Bulletin Number - BP3 Promenade - Bulletin 08

Project	Steamboat Base Village Redevelopment	Date	08/06/2021
Project Location	Steamboat, Colorado	Architect's Project Number	03.7835.000
Owner/Client	Alterra Mountain Company / East West Partners	File	6BL This is page 1 of 2
To	Saunders Construction Inc.	Attention	Bryan Sculthorpe
Address	86 Inverness Place North		
City	Englewood	State	CO Zip Code 80112
Delivered via:	<input type="checkbox"/> Messenger <input type="checkbox"/> Hand carried <input type="checkbox"/> Facsimile <input type="checkbox"/> Express <input type="checkbox"/> Pick-up <input type="checkbox"/> E-mail Address <input type="checkbox"/> Mail <input type="checkbox"/> UPS <input checked="" type="checkbox"/> Website Address BIM360

Description of Changes

1A-M1.400

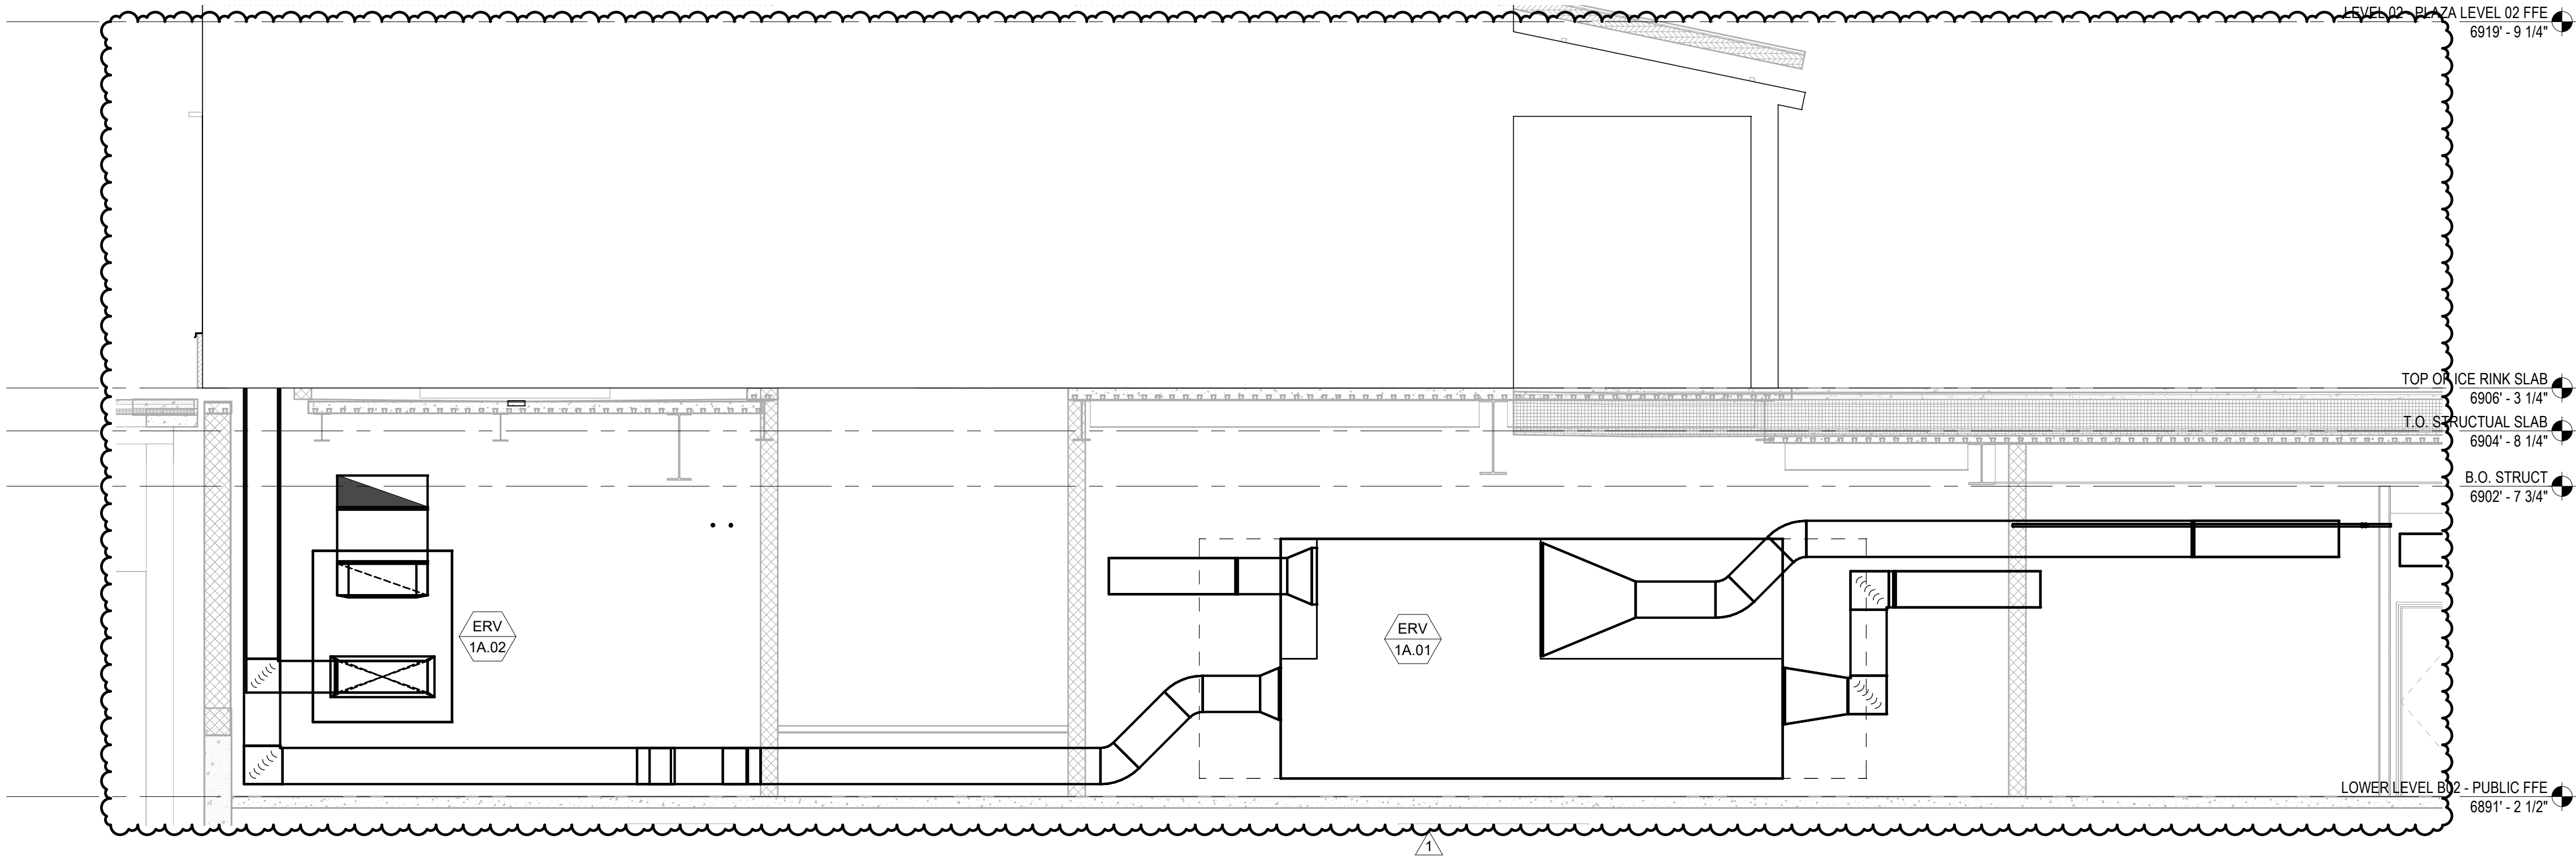
- b. Revised refrigerant skid vent riser location.
8. 1A-M1.400
 - a. Revised mechanical room layout including relocated equipment and controls.
 - b. Revised sheet metal above Zamboni pit.
